REQUEST FOR DRAWING CHANGE APPROVAL

IN THE DRAWINGS:

FIG.5

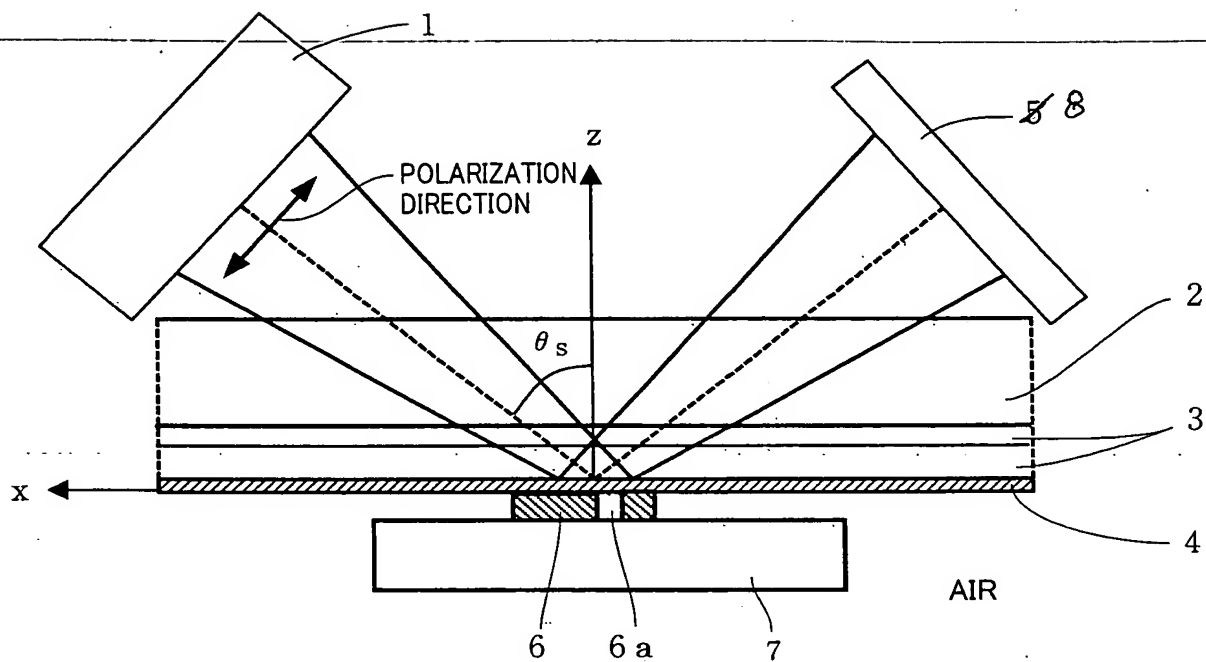
In Fig. 5, please change the reference numeral "5" to -- 8 --.

2. Objected to the formal drawings filed on 3 March 2005 on the basis that they fail to comply with 37 CFR §1.84(p)(4) because the reference character "5" has been used to designate both the Evanescent wave and the Photodetector as shown in Figures 1 and 3 on the one hand and 5 on the other hand, respectively. **Applicant has by the foregoing requested approval of a change to Fig. 5 of the drawings as originally filed that would delete the reference numeral "8" from Fig. 5 and substitute the reference numeral -- 5 -- therefor. A copy of the drawing sheet containing Fig. 5 showing the proposed change in red and a replacement sheet for the sheet of drawing containing Fig. 5 are both enclosed herewith as required by the Rules. Entry of the so proposed change to the drawings of this application and withdrawal of the currently outstanding drawing objection in view thereof is respectfully requested in response to this submission.**
